Docket Number:	22-BSTD-01
Project Title:	2025 Energy Code Pre-Rulemaking
TN #:	253197
Document Title:	BAC Comments on Cooling Tower Measures
Description:	N/A
Filer:	System
Organization:	Baltimore Aircoil Company (BAC)
Submitter Role:	Public
Submission Date:	11/17/2023 1:49:41 PM
Docketed Date:	11/17/2023

BAC Comments on Cooling Tower Measures

CEC Docket 22-BSTD-01

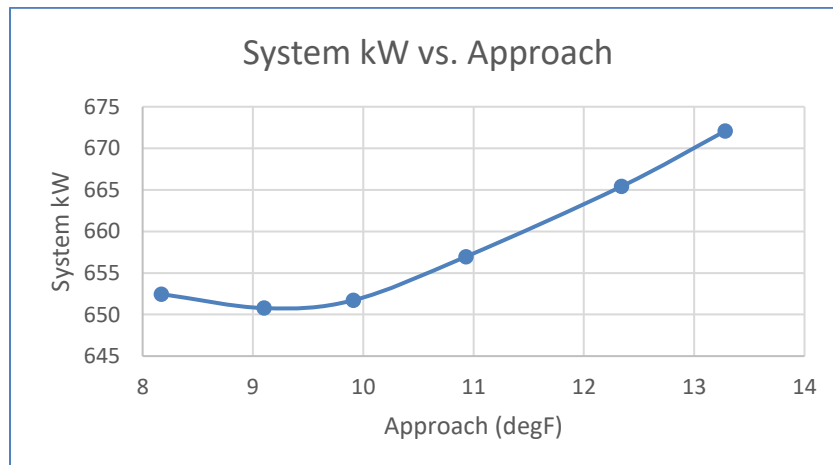
According to an experienced manufacturer's representative in CA that regularly evaluates cooling tower and chiller selections on projects to optimize overall energy efficiency at central utility plants, energy usage and costs will generally increase as GPM/HP increases. The key is to minimize system energy, not just the energy of one component, especially a component that accounts for a relatively small portion of the overall energy use.

The following chart illustrates that when a chiller plant stays within an 8°F to 10°F approach, chiller energy usage is minimized and plant efficiency is optimized. Our experience has been that an unreasonably high, prescribed GPM/HP for the cooling tower may inadvertently increase system energy. Because of this, we recommend evaluating more appropriate ways to improve total system efficiencies in future revisions, such as control sequences found in ASHRAE Guideline 36. Therefore, we respectfully suggest maintaining the current prescriptive requirements listed in Title 24 2022 (i.e., 60 GPM/HP) and delete the proposed energy rating increase.
